# Land south of Newfoundland Road, Deepcut

Ref: ITS19098-001C Reserved Matters Transport Statement  
Date: 13 November 2023

Image 4.2: Proposed Access Gradients

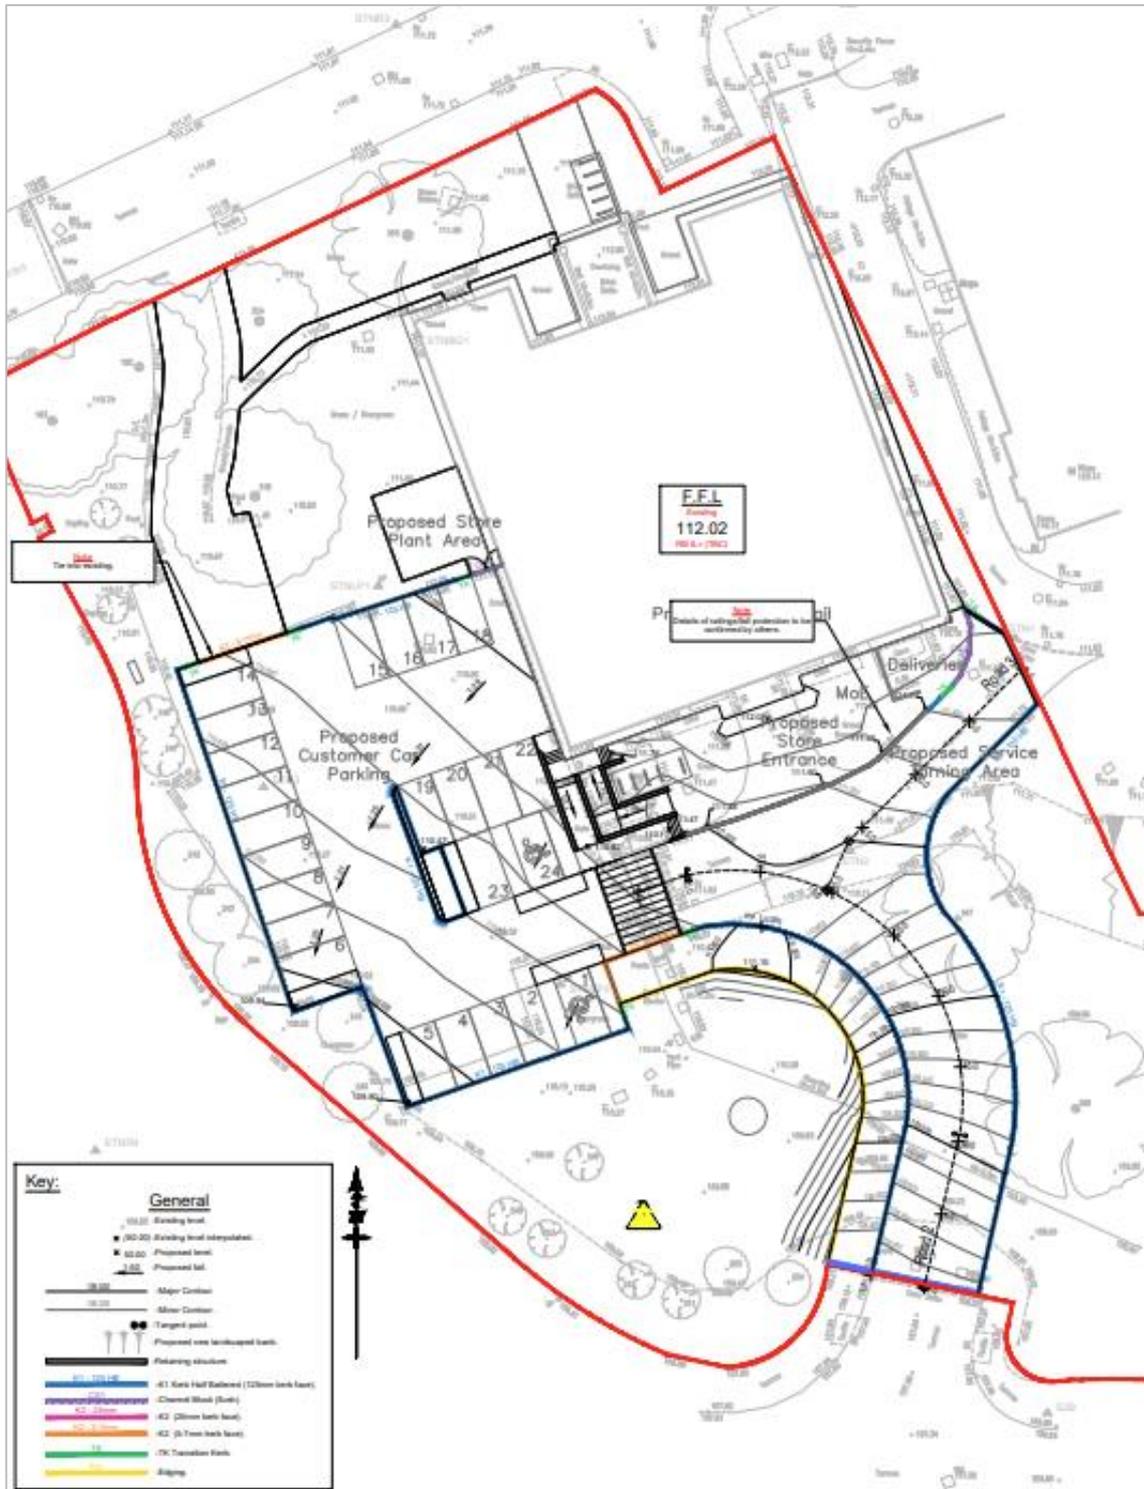
7. Provide hardstanding at parking by verges.	Agreed.
8. Show gradients on plan.	Agreed. Chainages and long sections are shown in engineering drawings in <b>Appendix C</b> .

4.2.6 The transitions in gradient on the access ramp will have a K value (measuring the rate of change of curvature) of 1, which is appropriate for a design speed of 20mph (ref: SCC’s design guidance *Technical Appendix A, table on page 20*). A drawing illustrating the vertical alignment of the site access is included as **Appendix C** and is reproduced below.

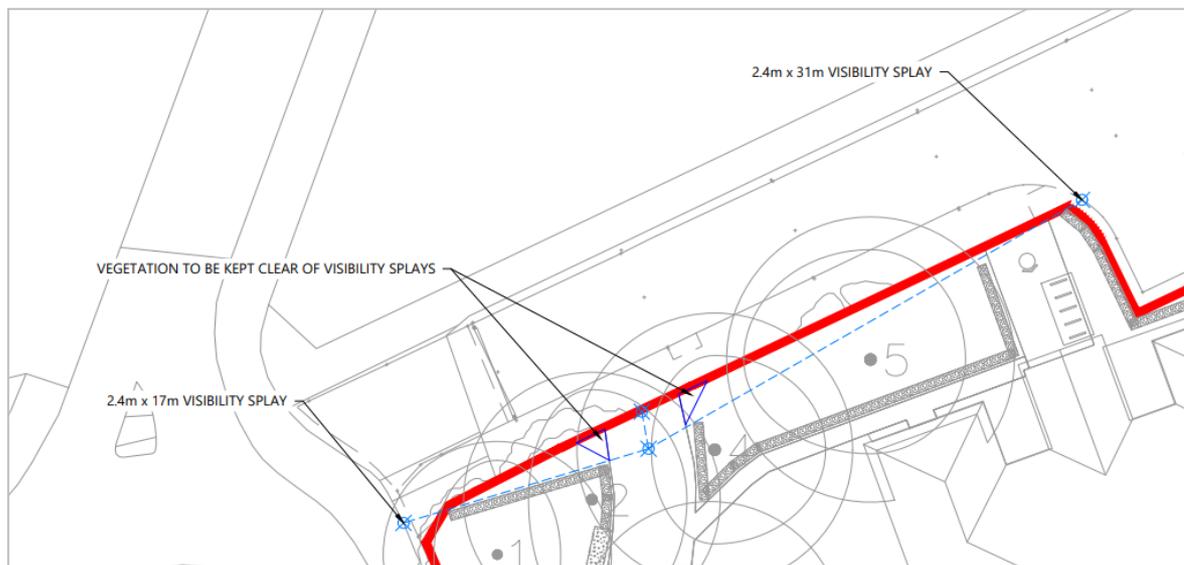
14. What is minimum width of footway?	3m (previously 2.4m was proposed)..
15. Provide 3m internal footway.	Agreed. To be available for cyclists too.
16. Drivers will encounter difficulty exiting space 24	Agreed. The area has been reconfigured. A hatched area to the right will separate the space from the adjacent wall.

- 4.2.8 A 3m wide shared cycleway will be provided immediately west of the vehicular access, connecting with shared cycleways on Mindenhurst Road. This will lead to an on-site controlled parallel crossing of the access road to the 'store side' (4m wide in accordance with SCC's preferences). Steps and ramps (1:15 gradient) will provide connections to the building entrance and cycle parking. The shared cycleway and crossing have been widened in response to SCC comments.
